TO Katherine Dorofaeff, Principal Policy Planner
FROM Dr Jack McConchie, Technical Principal
DATE 12 January 2015
SUBJECT M.Y. & S.A. Blackburne (Submission 44-11)

M.Y. & S.A. Blackburne in their submission on the Proposed Kapiti Coast District Plan (Submission 44-11) seek:

Figure 1: Location of the Ohariu Fault and disputed fault avoidance area (circled in red).

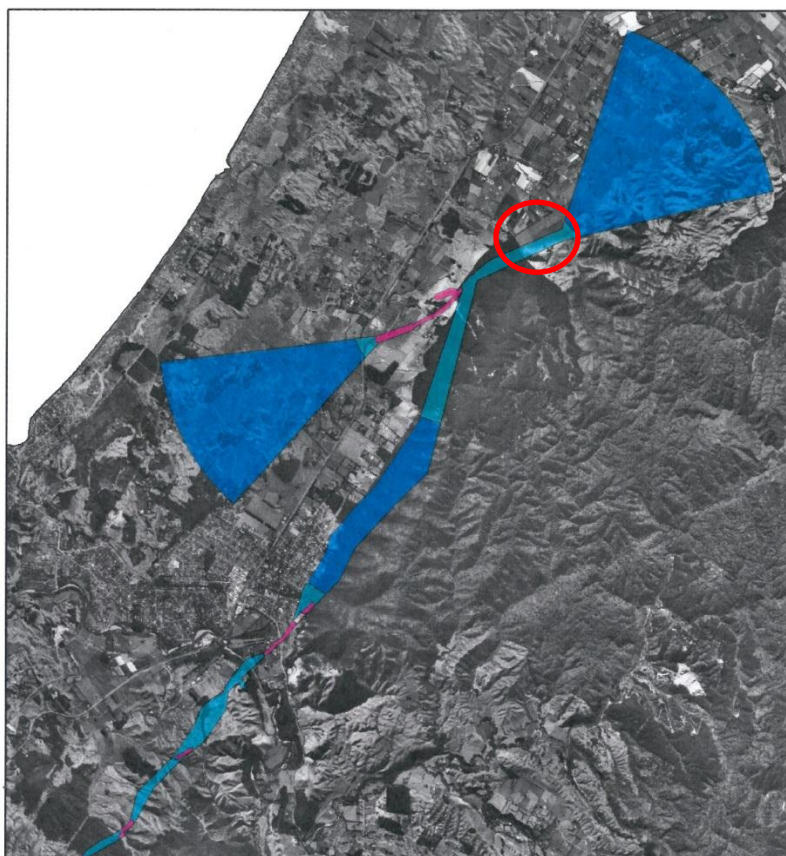
4. *Remove the fault avoidance area notation on 41 Blackburne Road: because there is no (or insufficient) evidence that any fault exists.*

The submission provides no evidence or argument for the removal of the section of the Ohariu Fault (Northern End), described as “Fault Avoidance Area - Uncertain Constrained”, shown on Map 18C – Natural Hazards appended to the Proposed District Plan.

Parts of the Ohariu fault fall into the well-defined, uncertain-constrained, and uncertain-unconstrained complexity classes. In the area under dispute, the Ohariu fault is uncertain-constrained and based on a series of springs and saddles.

The submitter provides no evidence or argument supporting the removal of this section of the Ohariu Fault from the maps which form part of Proposed District Plan. The submission states that there is no, or insufficient, evidence that any fault exists.

However, as has been outlined, a robust process was followed in including the fault avoidance areas associated with Ohariu Fault, in the Operative District Plan by means of Plan Change 61. Consequently the fault should remain as shown.
